Product Change Notification

Product Change Notification Number: PDF-032

Title: Manufacturing Capacity Expansion for the 8-contact, 6 x 8mm, Very Thin Dual Flat No Lead Package (VDFN)			
Product Identification: Specific Adesto products offered in the 6x8 mm VDFN package (part number package suffix 'MW'). See Table I for a complete list of affected Adesto part numbers.			
Reason For Change	☒ Capacity Expansion	☒ Design	☒ Manufacturing Location
	☐ Material / Composition	☐ Processing/Manufacturing	☐ Quality & Reliability
Change Description: Addition of a qualified subcontractor for assembly and final electrical test services for products offered in the VDFN 6x8 mm package selection to further expand capacity. <i>NO external package dimensional changes, that would affect PCB board layout or device functionality, occur with this change (see Figure 1 for package thermal pad dimensions).</i>			
Quantifiable Impact on Quality & Reliability: No change in Quality or Reliability Affected products remain Form, Fit and Functionally compatible with the same products assembled in existing facilities. There is no impact on product availability or pricing

FIGURE 1 PACKAGE DIMENSIONAL CHANGES (published datasheet updated)

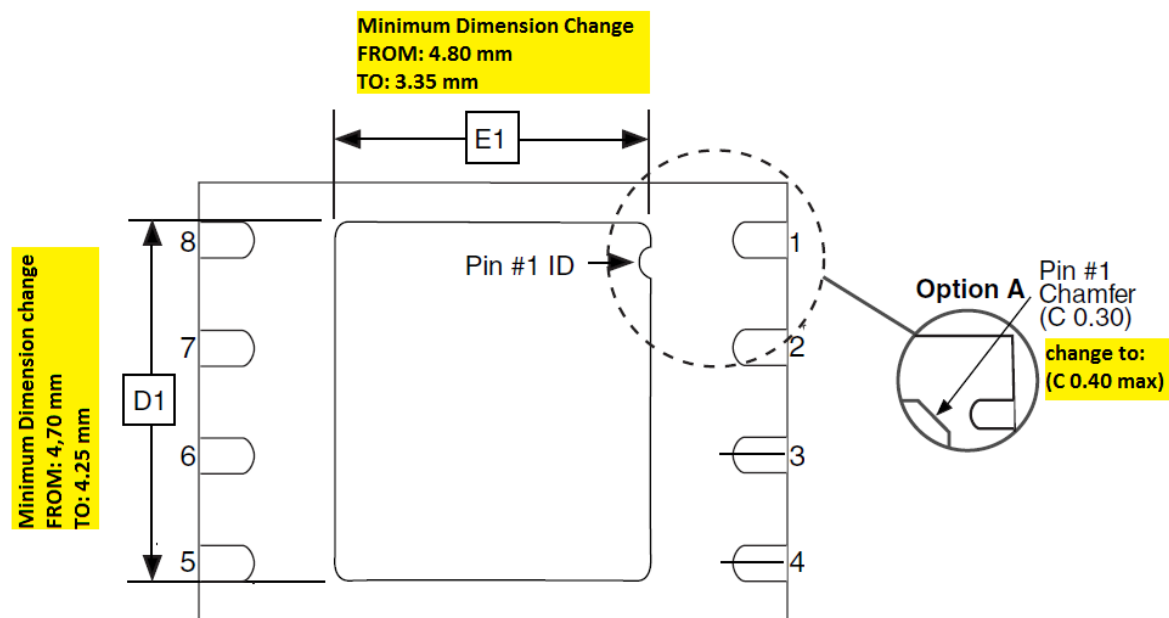
NO critical external package dimensional changes.

The minimum dimensions of the thermal pad have reduced as shown below.

Impact to board layout: NONE

These changes have no impact on board layout due to industry standard recommendation not to run PCB traces under the pad area.
